Project	<b>IEEE 802.16 Broadband Wireless Access Working Group</b> < <a href="http://ieee802.org/16">http://ieee802.org/16</a> >	
Title	<b>Maps Format in AAS</b>	
Date Submitted	<b>2004-03-12</b>	
Source(s)	Vladimir Yanover, Naftali Chayat, Tal Kaitz (Alvarion Ltd.) 21 A Habarzel St. Ramat - Hahayal Tel - Aviv 69710 P.O. Box 13139, Tel-Aviv 61131, Israel Paul Petrus, Adam Kerr (ArrayComm Inc.) Atul Salvekar, Hassan Yaghoobi (Intel)	Voice: +972-36457834 Fax: +972-36456222 <a href="mailto:tal.kaitz@alvarion.com">mailto:tal.kaitz@alvarion.com</a> <a href="mailto:vladimir.yanover@alvarion.com">mailto:vladimir.yanover@alvarion.com</a> <a href="mailto:naftali.chayat@alvarion.com">mailto:naftali.chayat@alvarion.com</a> <a href="mailto:petrus@arraycomm.com">mailto:petrus@arraycomm.com</a> <a href="mailto:adam@arraycomm.com">mailto:adam@arraycomm.com</a> <a href="mailto:atul.a.salvekar@intel.com">mailto:atul.a.salvekar@intel.com</a> <a href="mailto:hassan.yaghoobi@intel.com">mailto:hassan.yaghoobi@intel.com</a>

Re:	The document supports a comment in 802.16REVD Sponsor Ballot	
Abstract	Implementation of AAS MAPs and AAS Network Entry procedure suggested	
Purpose	The document is intended for

Figure MMM. AAS Zone, FDD

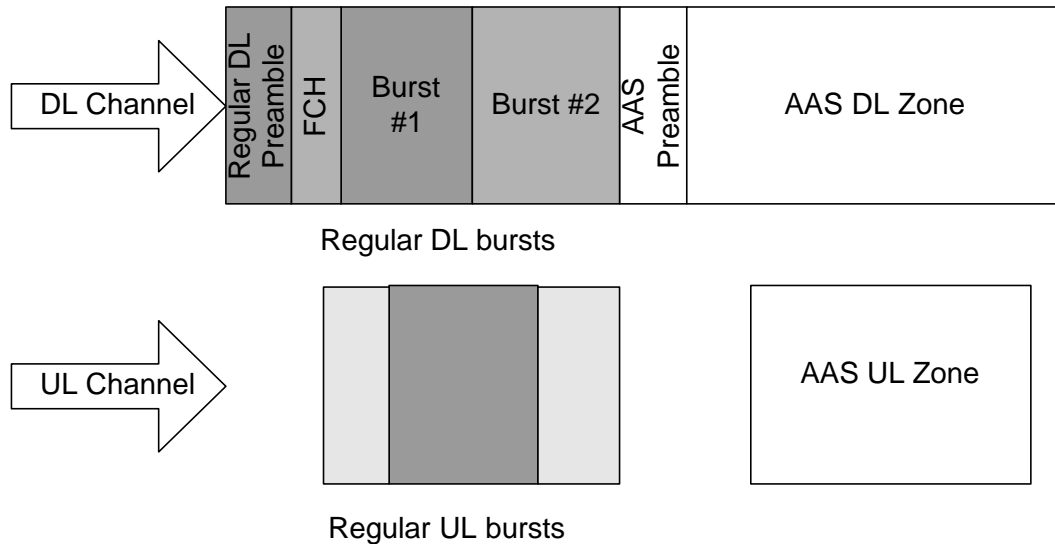
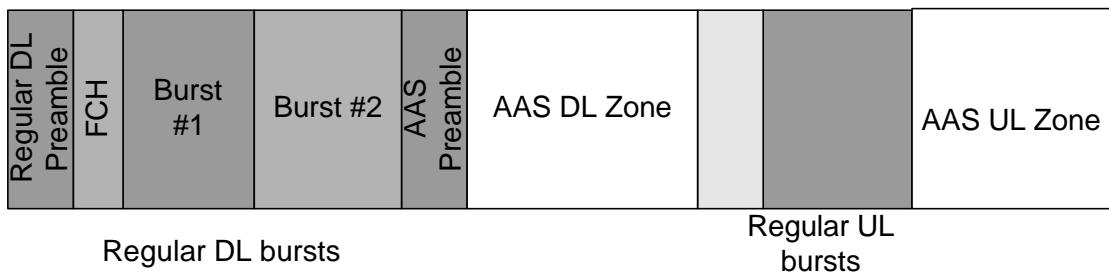
#### *[Change in 6.4.7.6.1 "AAS MAC services", p.160 line 41]*

This is achieved by dedicating part of the frame to non-AAS traffic and part to AAS traffic. The allocation is performed dynamically by the BS. Non-AAS Ss shall ignore AAS traffic, which they can identify based on the DL-MAP/UL-MAP messages.

The AAS part of the DL frame begins with an AAS specific Preamble, see Figure MMM and Figure NNN.

For bandwidth request / allocation AAS enabled SSs may use dedicated private DL-MAP/UL-MAP messages as well as tools specific for AAS (section 8.3.4.2). BS must prevent and are therefore prevented-AAS traffic from colliding with non-AAS traffic.

Figure QQQ. Structure of AAS Zone

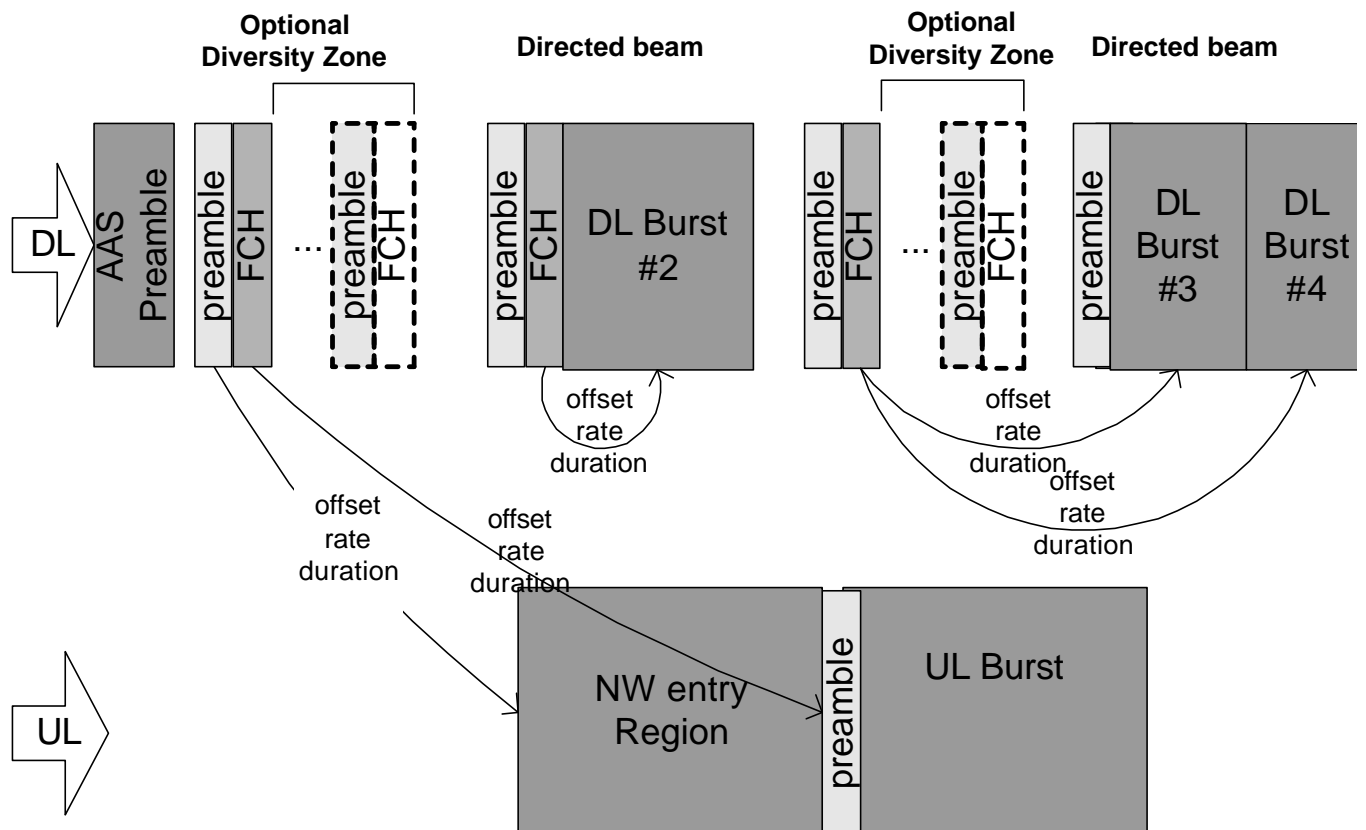
*[Insert a new section after 8.3.4.1]*

An example of AAS Zone layout is shown at Figure QQQ.
